City of
LAUNCESTON

COUNCIL AGENDA

**COUNCIL MEETING
THURSDAY 6 MAY 2021
1.00pm**

Figure 2
Primary frontage in green

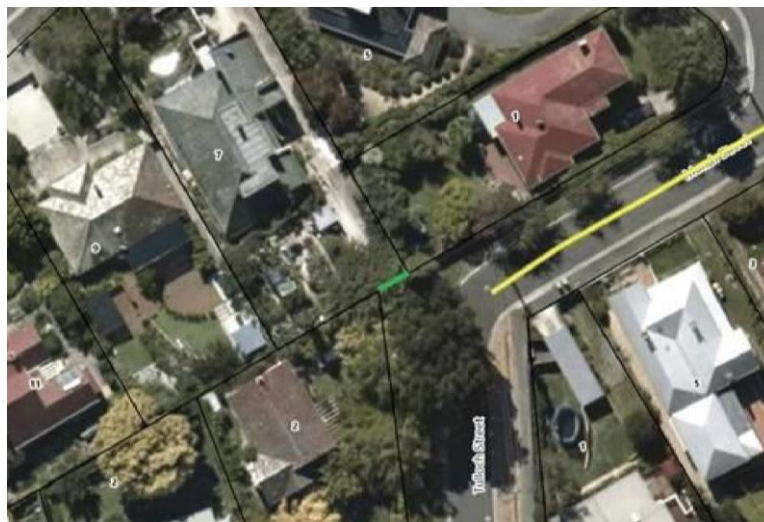
The subject site has two frontages. The frontage to Tulloch Street is the primary frontage as it has the shortest dimension (3.6m). Primary frontage is defined in the Scheme as *the frontage with the shortest dimensions measured parallel to the road irrespective of minor deviations and corner truncations*. The boundary of the site that abuts Tulloch Street is limited to the section of the boundary that faces Tulloch Street and Monds Street but excludes the common boundary to 2 Tulloch Street which is considered a side boundary. The primary frontage is highlighted in green in Figure 2.

A setback of 4.5m is required to the primary frontage. Due to the location of the lot at the corner of two streets, the required setback could be measured as a line parallel to Monds Street, Tulloch Street or both streets. For the purposes of this assessment, it will be measured parallel to both streets.

*Figure 3
Sections highlighted in blue outside building envelope -
estimated by the planning officer*

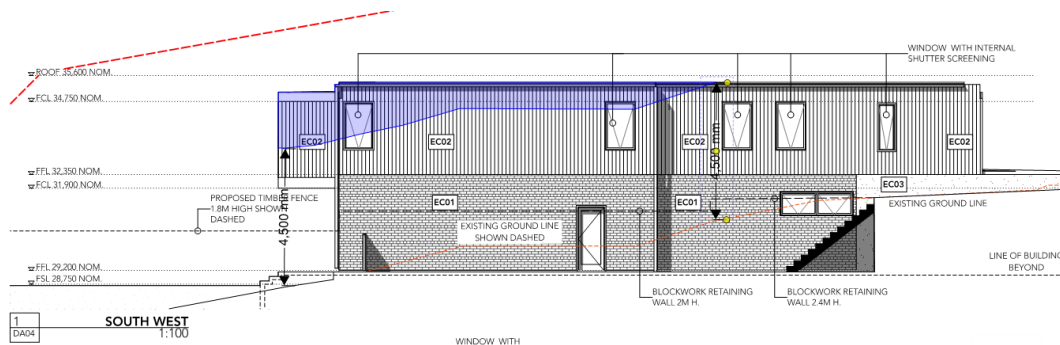
The proposed dwelling sits outside the building envelope set out in item (a)(ii) and item (b)(ii).

(a) (ii) The western side of the dwelling has a maximum building height of approximately 6.5m which requires a side setback of 3.5m to No. 9 Trotsford Crescent. A setback of 1.5m is proposed. The figure below shows in blue the areas of the proposed building that are setback 1.5m and should be setback 3.5m to meet the acceptable solution.

Figure 4
Sections highlighted in blue outside building envelope - estimated by the planning officer

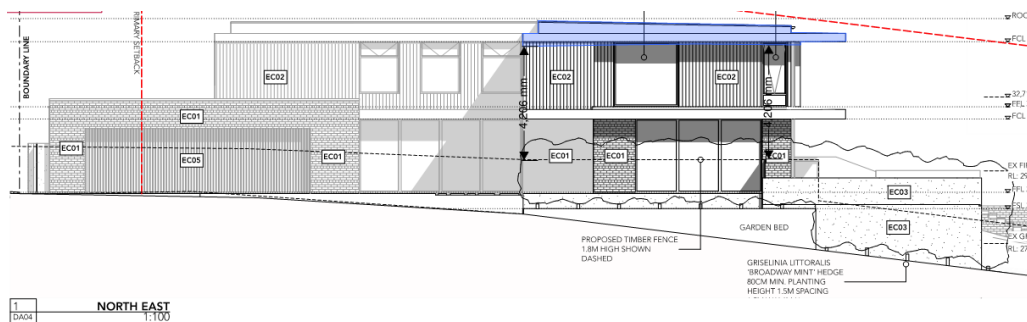
The eastern side of the dwelling has a building height of approximately 5.2m which requires a side setback of 2.2m to No. 5 Trotsford Crescent. A setback of 1.3-1.4m is proposed.

(b)(ii) A minimum 1.4m setback is proposed along the north-eastern side boundary for a length of over 11m.

Figure 5
Sections highlighted in blue outside building envelope - estimated by the planning officer

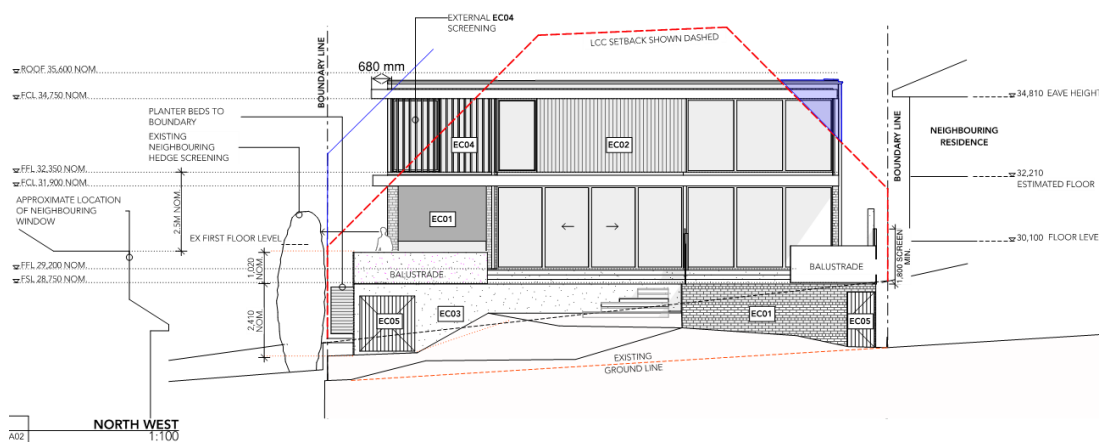
(a) (iv) The dwelling proposed is not considered to result in detrimental visual impacts to adjoining properties. It will be setback over 10m from the dwelling at No. 5 Trotsford Crescent. It will be setback approximately 2.3m from the dwelling at No. 9 and as the land slopes up to east, the proposed dwelling will almost match the roof level of the existing property to the west (No. 9). Best shown in the north-west elevation below:
